**Monitoring Report
Hofler Property
Monitoring Year 7**
DMS Project ID #: 95355
DMS Contract #: 004628
USACE AID# SAW-2012-01393
Gates County, North Carolina
Submitted February 2022

RE: Hofler Monitoring Year 7 Report

Ecotone, Inc. has addressed the comments made on December 15, 2021 by DMS for the above referenced project. The following is a point-by-point response addressing those comments. Additionally, an updated copy of the MY7 Report will be submitted.

Hofler Restoration Project
Current Condition Plan View
 Project # 95355
 Feb. 2022

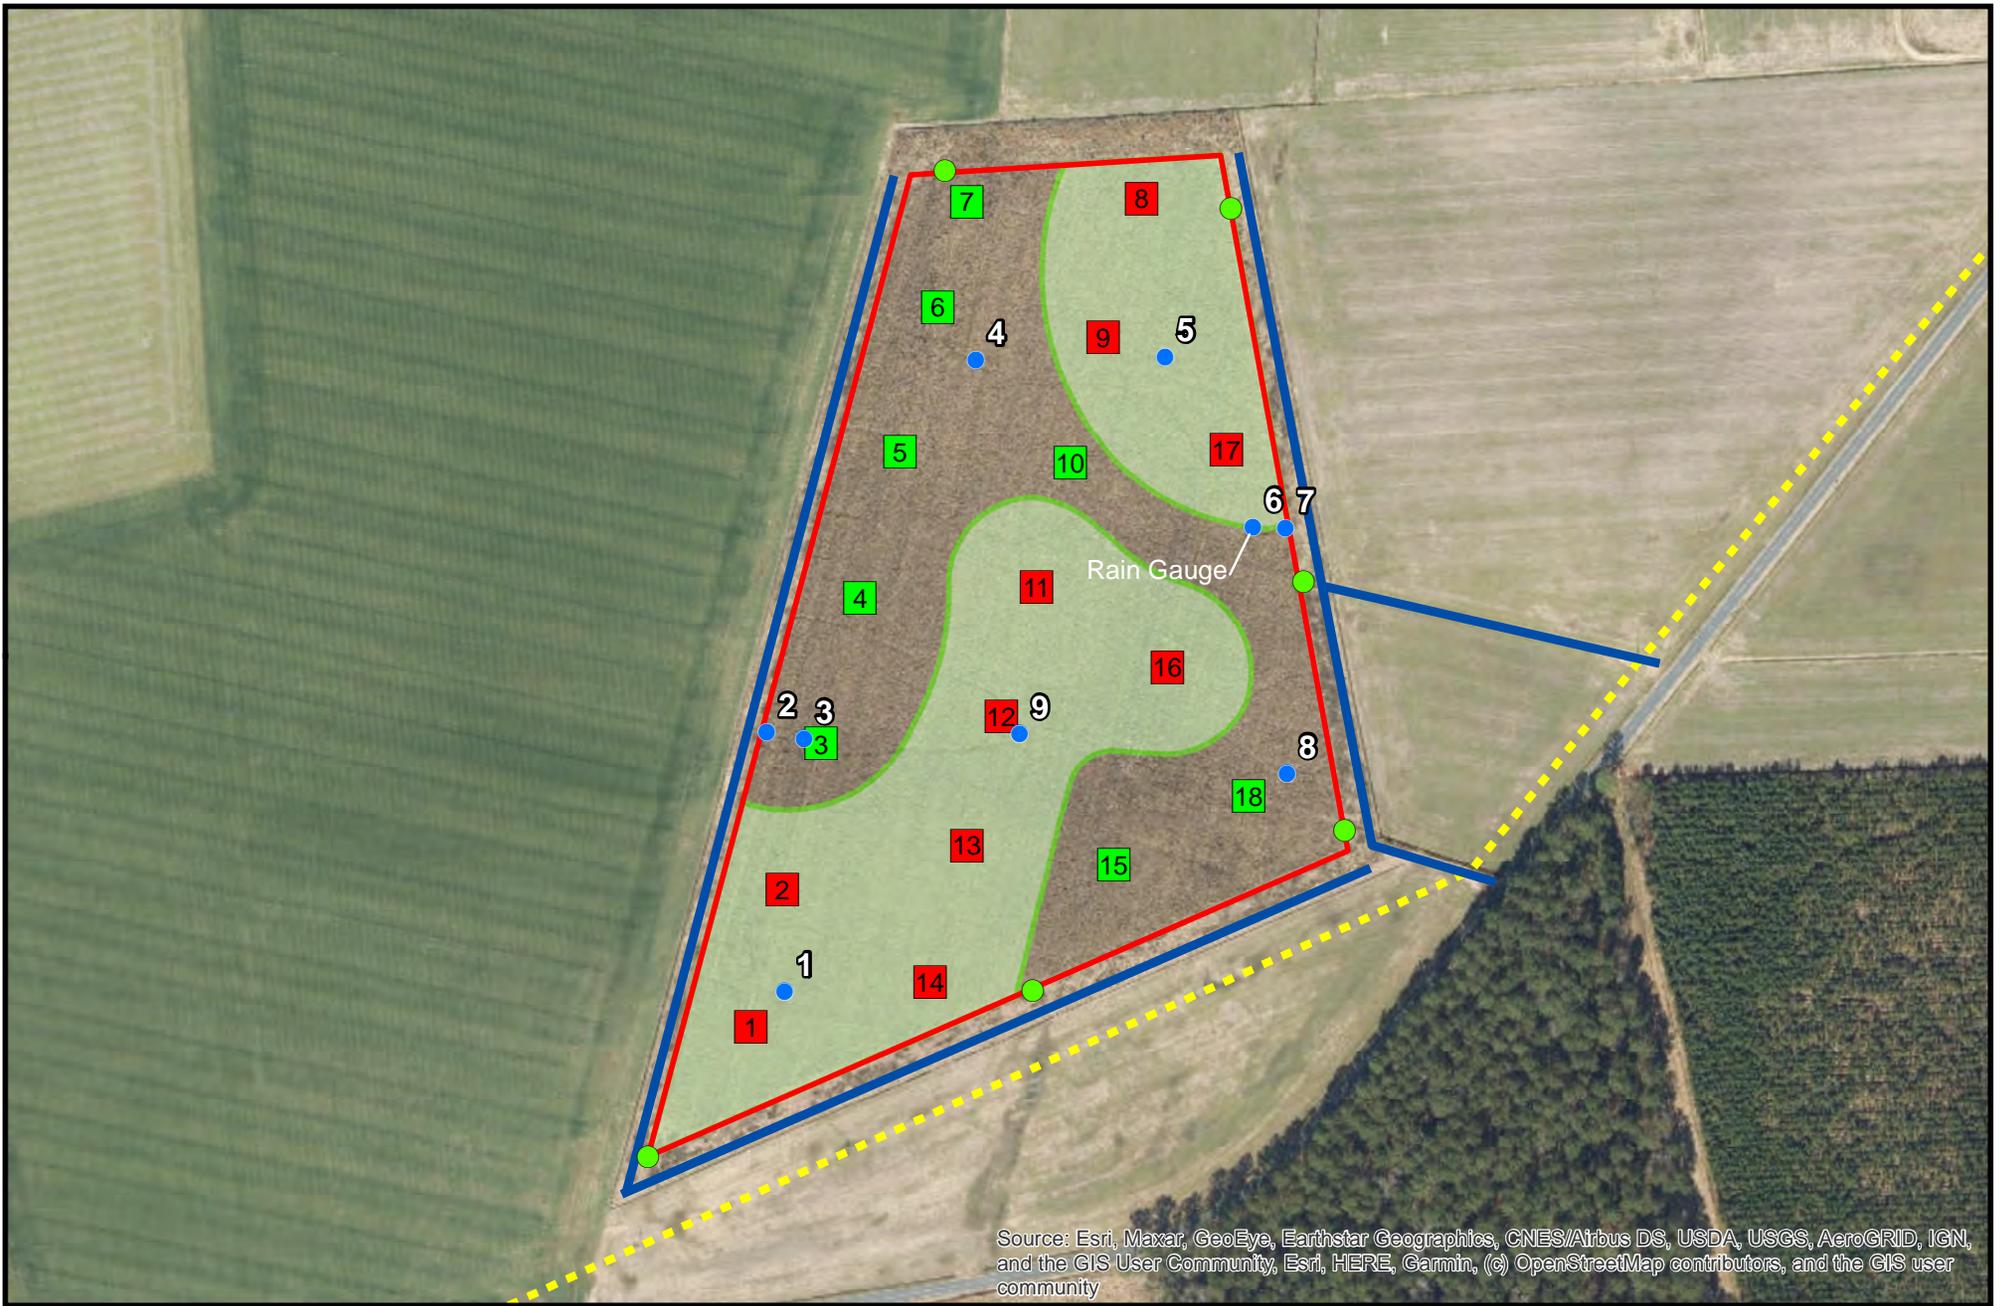
- 1. Please provide narrative or show on map exactly where the ditch plugs were lowered*
Ecotone Response: Locations of where ditch plugs were lowered are now depicted on the CCPV on Page 12.

6. *The visual assessment table shows 12.79 acres as bare areas. Show these areas as a shapefile on your CCPV.*

1. *Please include a figure representing the low stem density areas and areas of poor growth rates or vigor and include these features in the CCPV.*

Ecotone Response: Table 5 on page 13 shows 0.00 acres of bare areas and 12.79 acres of low stem density areas. These areas have been marked on the CCPV, included on page 12 of the report.

Ecotone Response: The areas of low stem density (12.79 acres) and the 23 acres of poor growth/vigor are indicated on the CCPV included on page 12 of the report.

Ditch Plug 4
11/24/2020

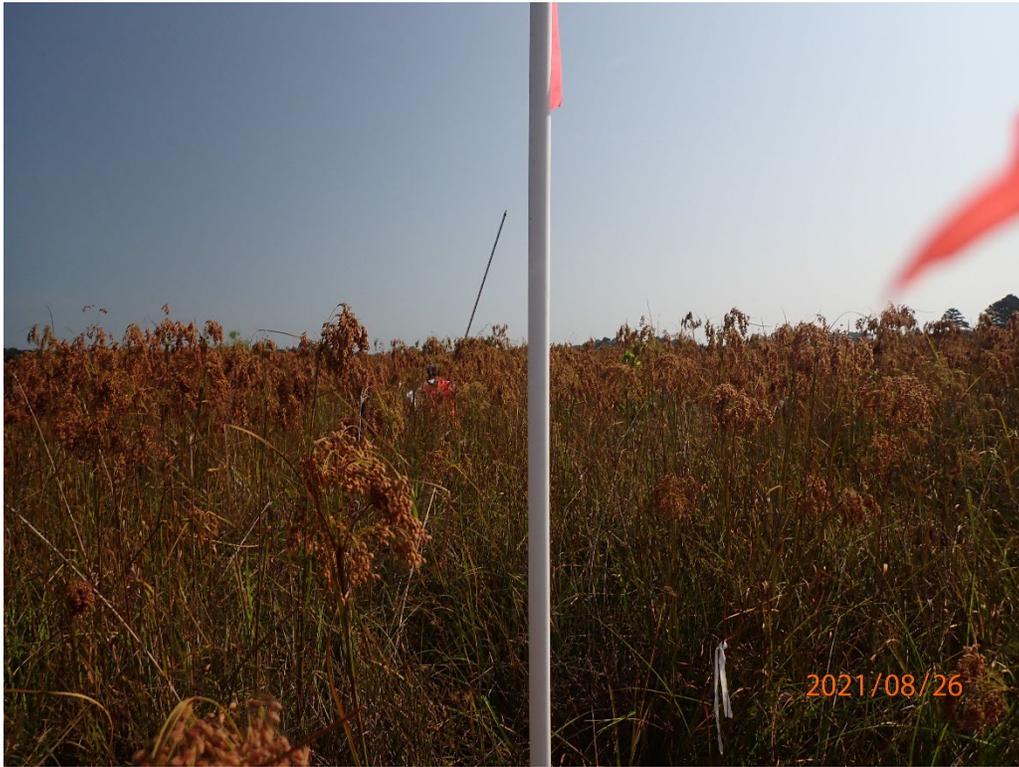
- 4. Table 2. Add the date that ditch plugs were modified. Provide before and after pictures with date stamp.*
Ecotone Response: Ditch plugs were modified on November 24, 2020. This is included in Table 2, page 9 of the report.

Hofler Monitoring Gauge #1 (20962824)

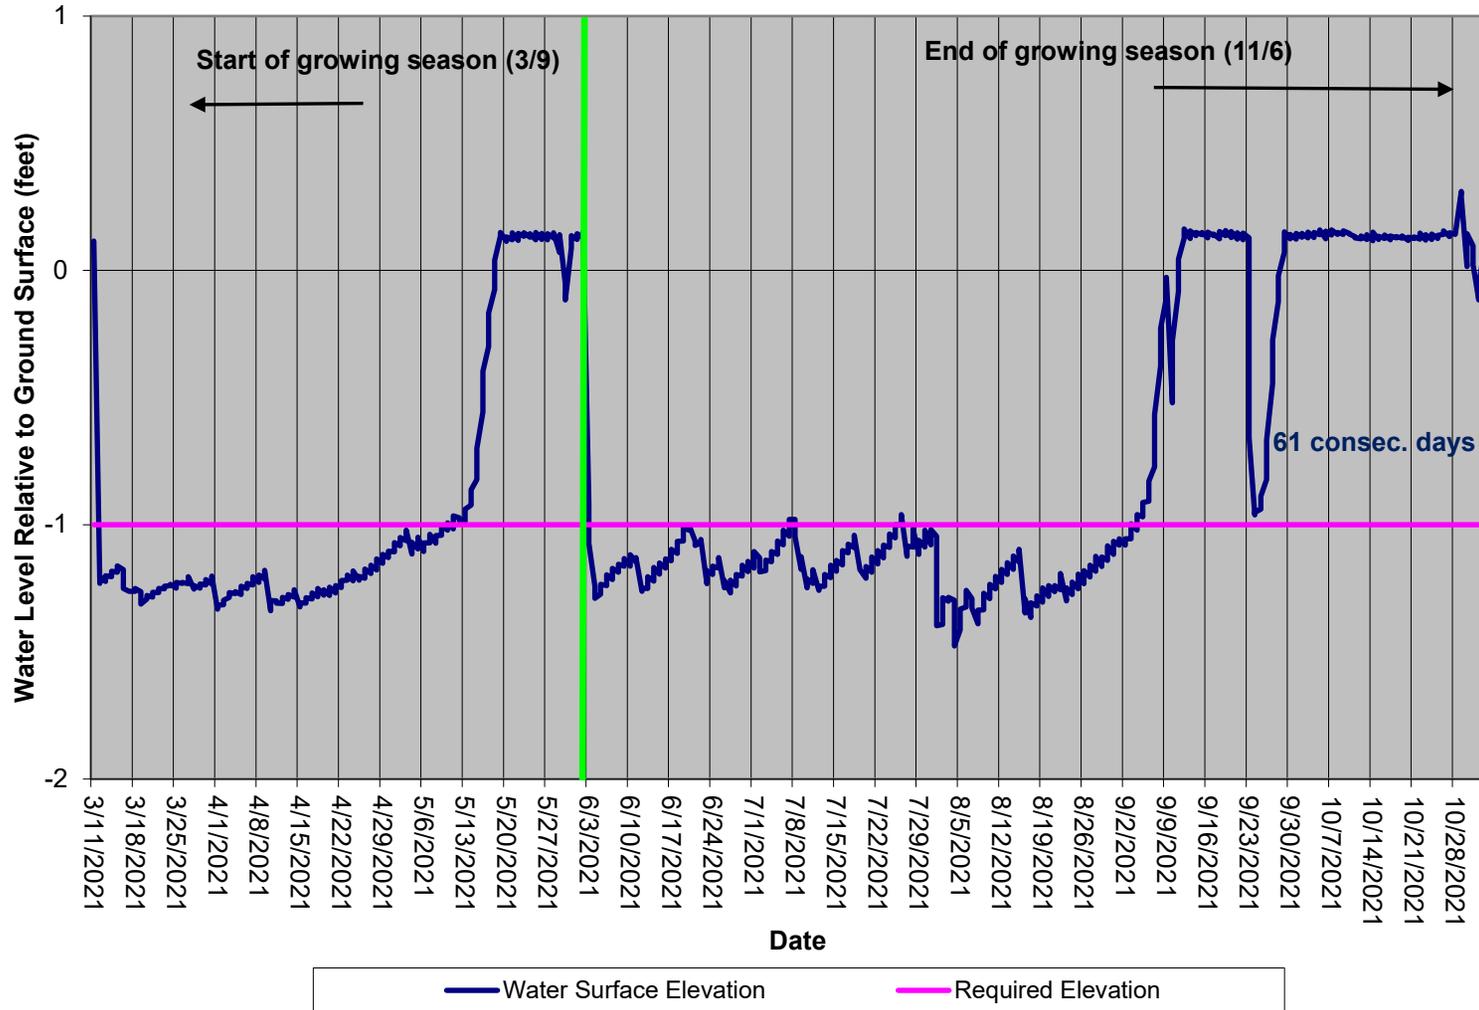
2. *The start of growing season line for gauge 1 is misplaced. Also, please include the start of growing season date in all groundwater gauge figures.*

Ecotone Response: Start of growing season line for gauge 1 has been fixed. Start of growing season dates have been provided for all groundwater gauge figures.

Hofler Monitoring Gauge #7 (20962765)

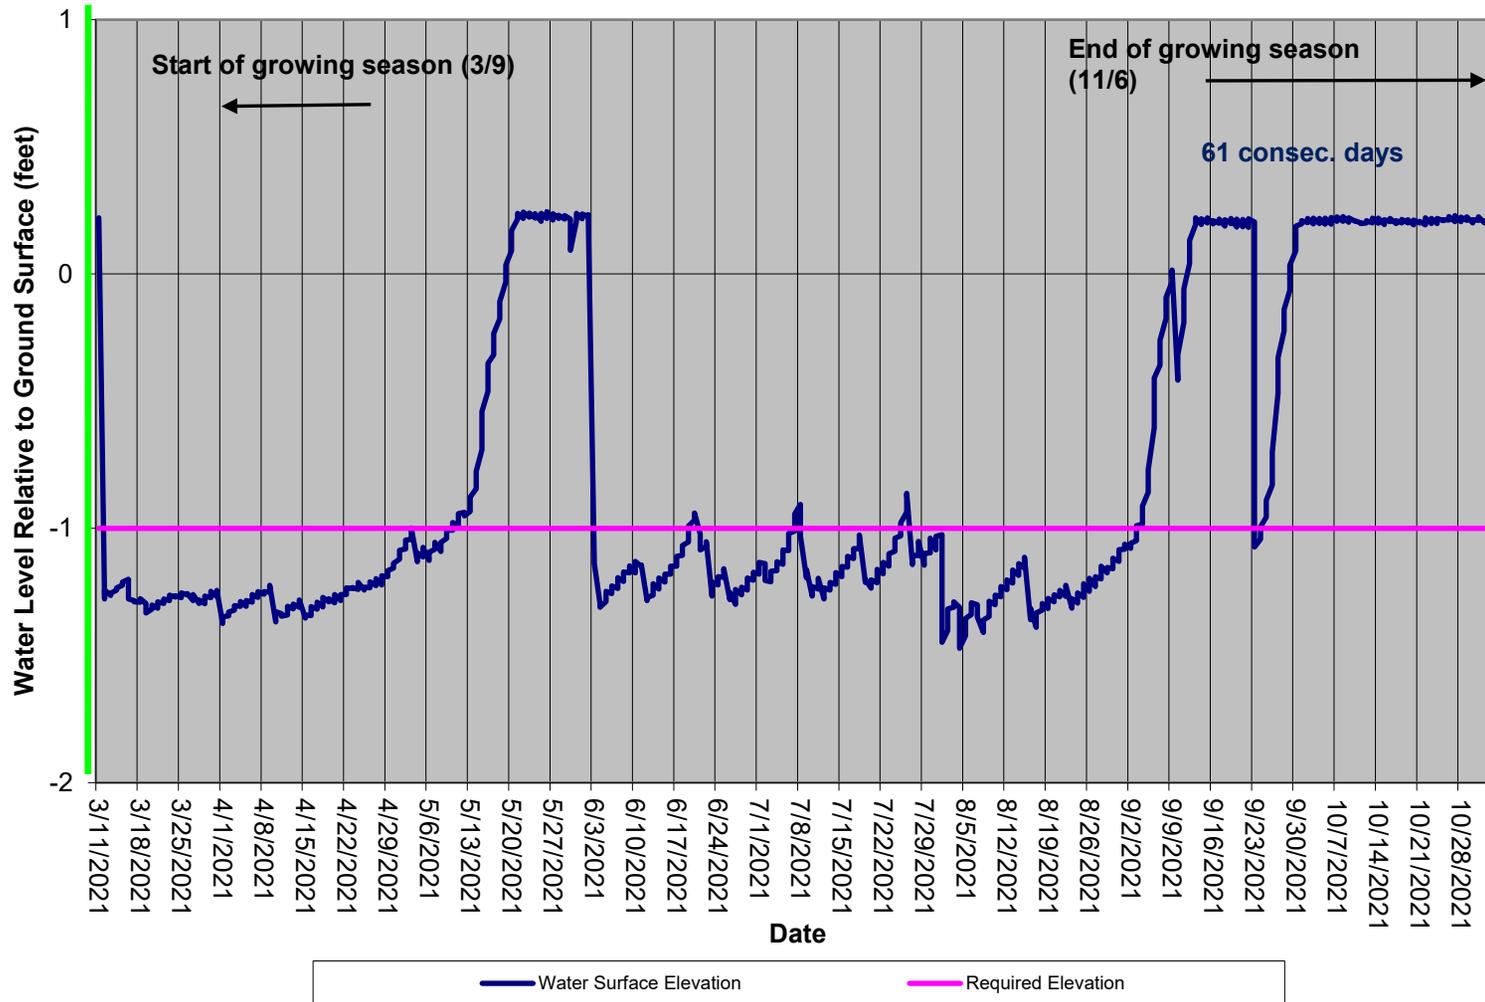
3. *Please review the reported consecutive days for wetland gauge data. Gauge 7, for example, appears to show only 40 consecutive days after 9/24.*

Ecotone Response: Maximum consecutive hydroperiods have been reviewed for all gauges and updated in Table 8. Gauge 7 now shows a period of 61 days and Gauge 9 shows a period of 87 days.
